TRANS/WP.29/GRSP/2004/6  
20 February 2004

Working Party on Passive Safety (GRSP)  
(Thirty-fifth session, 3-7 May 2004,  
agenda item B.1.4.)

PROPOSAL FOR DRAFT AMENDMENTS TO REGULATION No. 44  
(Child restraints)

Transmitted by the expert from France

TYPE APPROVAL SCHEME (FLOW CHART ISO 9002)

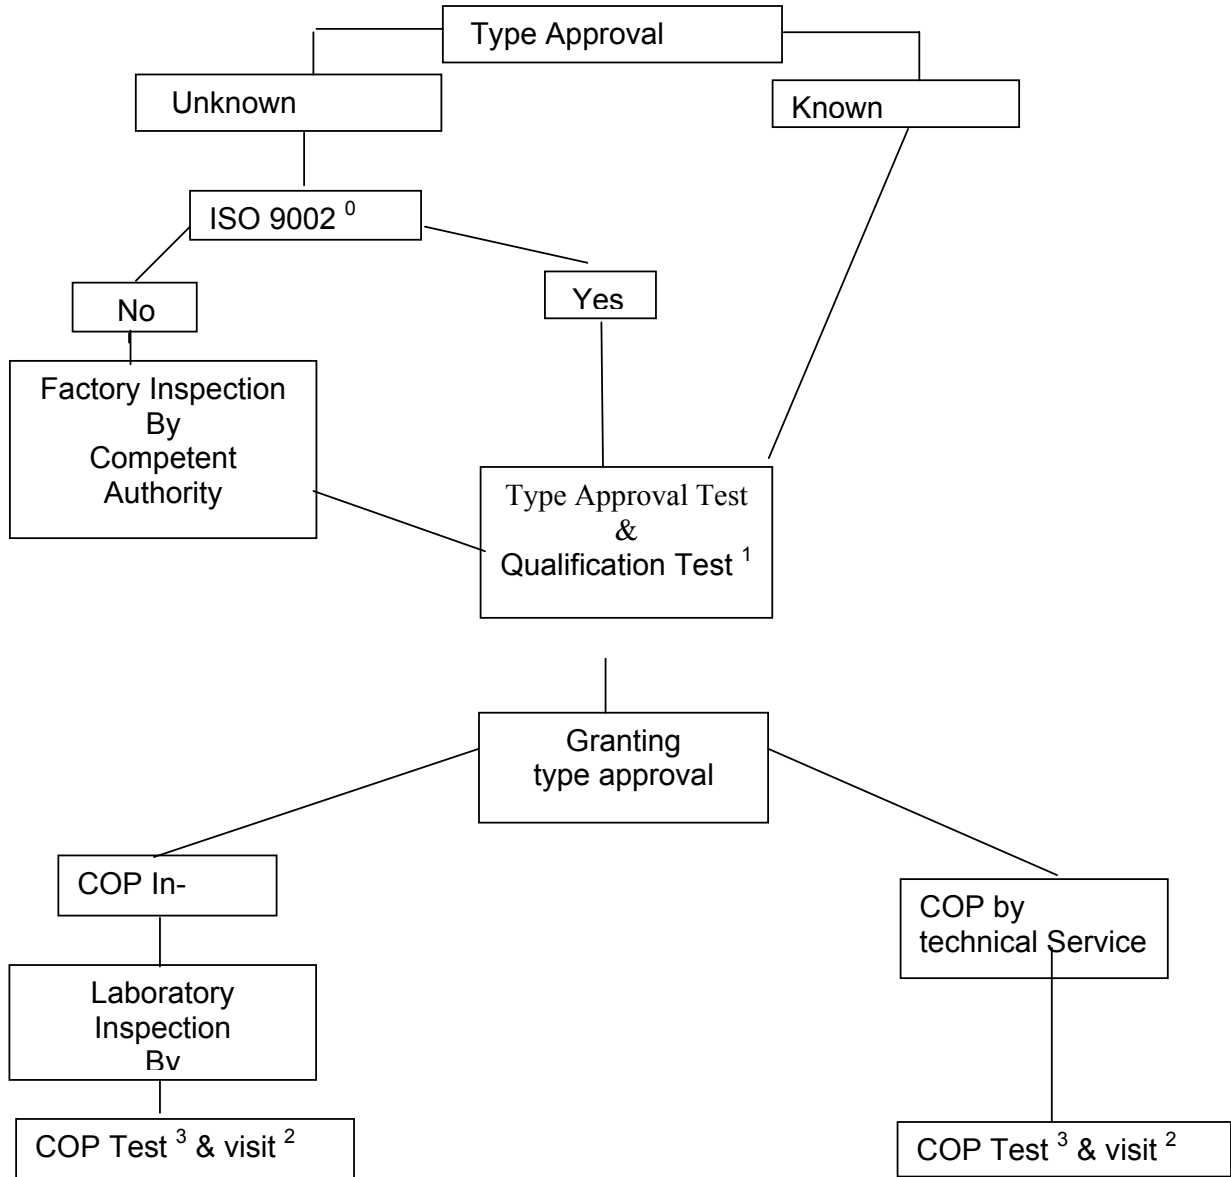
Insert a new annex 14, to read:

"Annex 14

- 0) or an equivalent standard to this one
- 1) these tests shall be done by technical service
- 2) visit to the manufacturer for inspection and random sampling by the Authority or technical service
  - a) if there is no ISO 9002: 2 times a year
  - b) if there is an ISO 9002: 1 times a year
- 3) tests in accordance with annex 16
  - a) if there is no ISO 9002:
    - i. of the Authority or technical service during the visit of footnote 2a
    - ii. of the manufacturer between the visits of footnote 2b
  - b) if there is an ISO 9002: taken by the manufacturer, procedure checked during visit of footnote **2b**.
